Town of Hilton Head Island Planning Commission LMO Committee

TO: Planning Commission
VIA: Teri Lewis, AICP, *LMO Official*
FROM: Heather L. Colin, AICP, *Development Review Administrator*
DATE: September 12, 2012
SUBJECT: The Mall at Shelter Cove Exhibit D of the proposed Development Agreement

EXHIBIT D
Shelter Cove Mall Redevelopment
Modifications to
Town of Hilton Head Island's Land Management Ordinance

B. Adjacent Street Setback. Minimum setback distances from adjacent roads are specified in the table below.

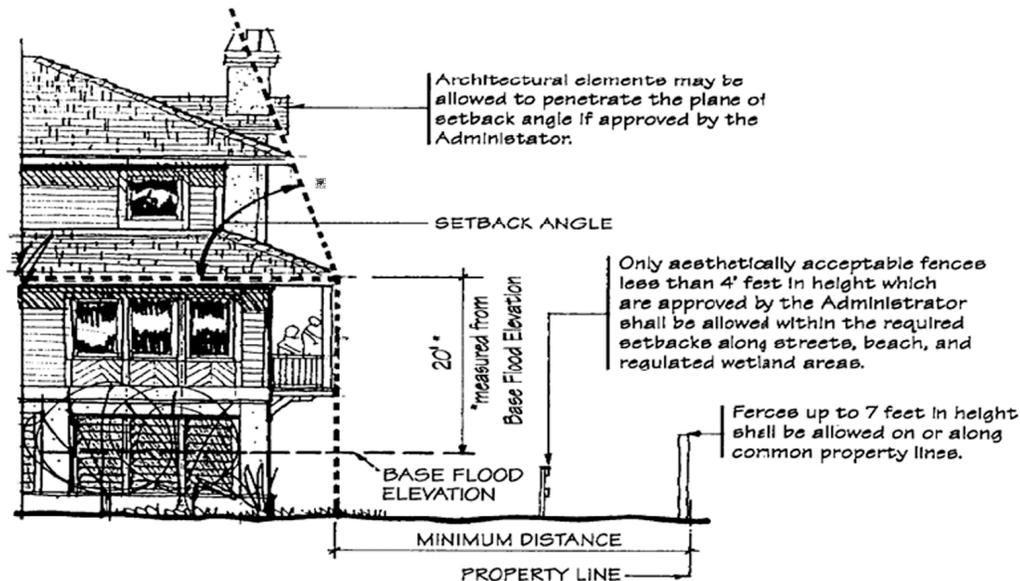
b. Sec. 16-5-704. - Adjacent Street Setback

Modify B. to include the following:

“Where non-residential buildings front on-street parking, adjacent street setback may be reduced to zero with no setback angle requirement, provided a minimum 10’ sidewalk corridor is maintained.”
